## TOWN OF KILLINGLY PERMANENT BUILDING COMMISSION

ITEM 4(a): KILLINGLY MEMORIAL SCHOOL RENOVATION/ADDITION PROJECT

Prime Contract Potential Change Order #001: PR-003 Roofing Value Management

### **Proposal Request**

410\_1A-1R1.1\_REV1 - PARTIAL ROOF PLAN 411\_1A-1R1.2\_REV1 - PARTIAL ROOF PLAN 412\_1A-1R1.3\_REV1 - PARTIAL ROOF PLAN 413\_1A-580\_REV1 - ROOF DETAILS 414\_1A-581\_REV1 - ROOF DETAILS

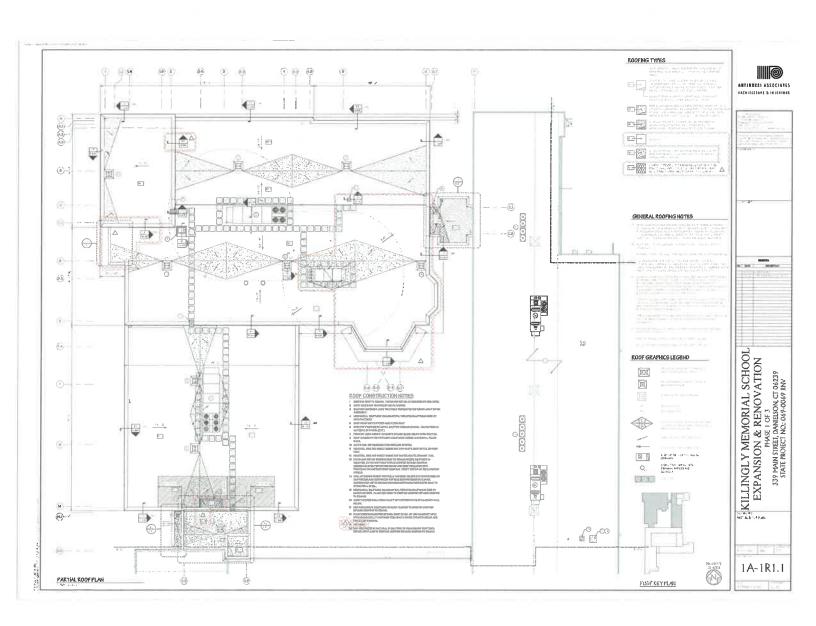
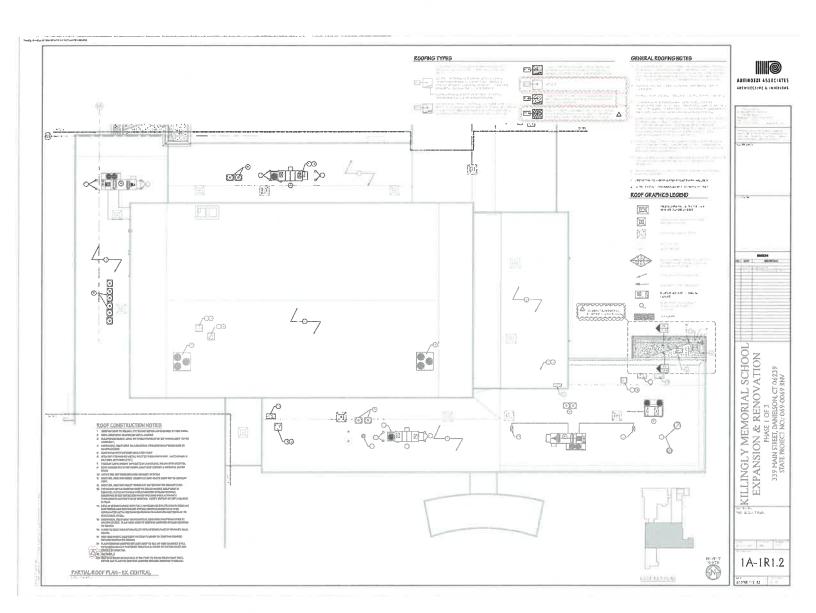
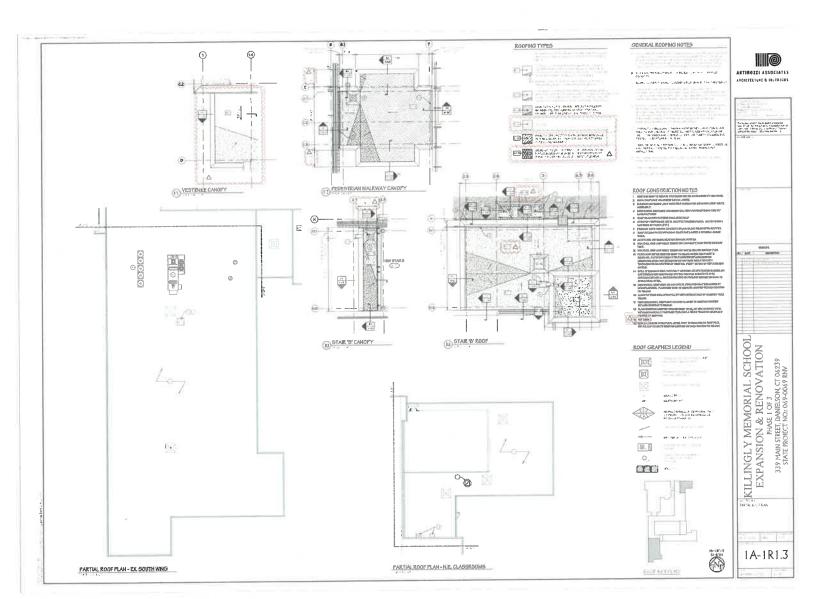
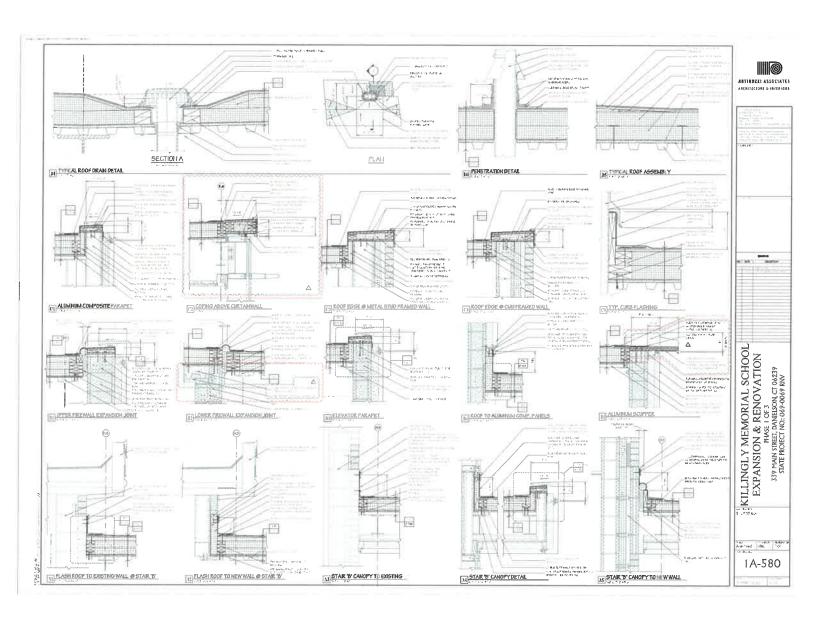
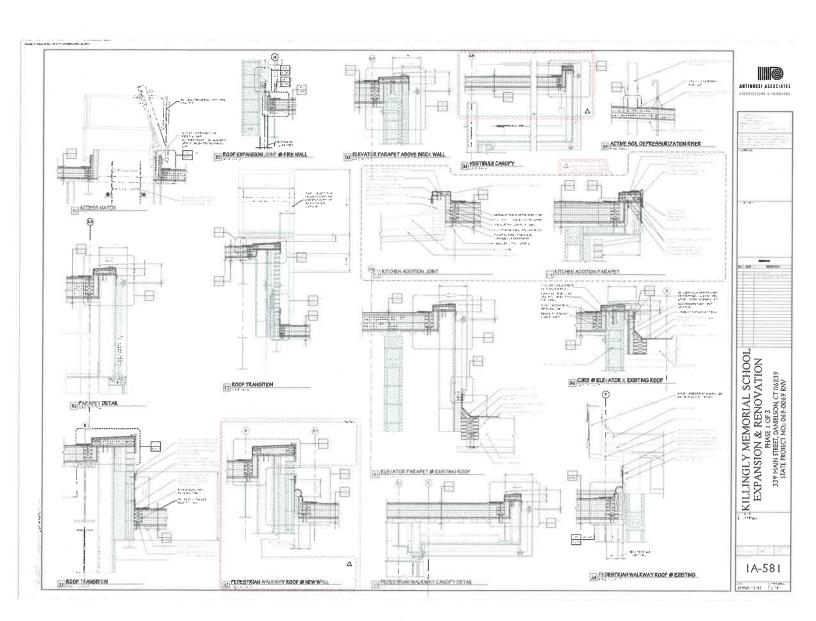
Furnish credit for value management changes to the roofing scope of work in accordance with Antinozzi Associates PR-003, issued on 8/10/22 and dated 8/09/22.

Reference the attached documents detailing changes to the Roofing Drawings capturing additional Value Management / Value Engineering (VM/VE) Proposals, and changes associated with the installation of the new roof on the addition to the KMS building.
